Technical Note
Powered glider ASK 14
L - 684

No. 1

Suspension of the thermosbottles below the baggage

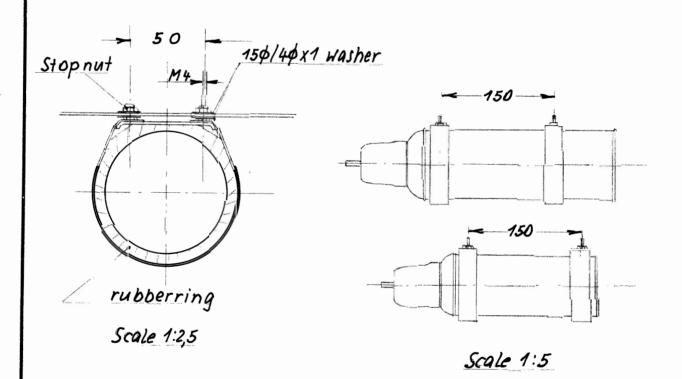
There is the suspection, that a bottle got loose and

blocked the controls.

Remove the bottle and cut off the present screws. Put the new suspension bands over the bottle and push the rubber ring between. Bring the bands to the correct distance, see sketch. Thrill the holes in the plywood from above, so that the bottles come at their old place. If there is any equipment it should be removed for that work. Install the bottles. There must be a 15 mm dia. washer at both sides of the plywood. Connect the bottles in the correct sense

to the instrument lines.
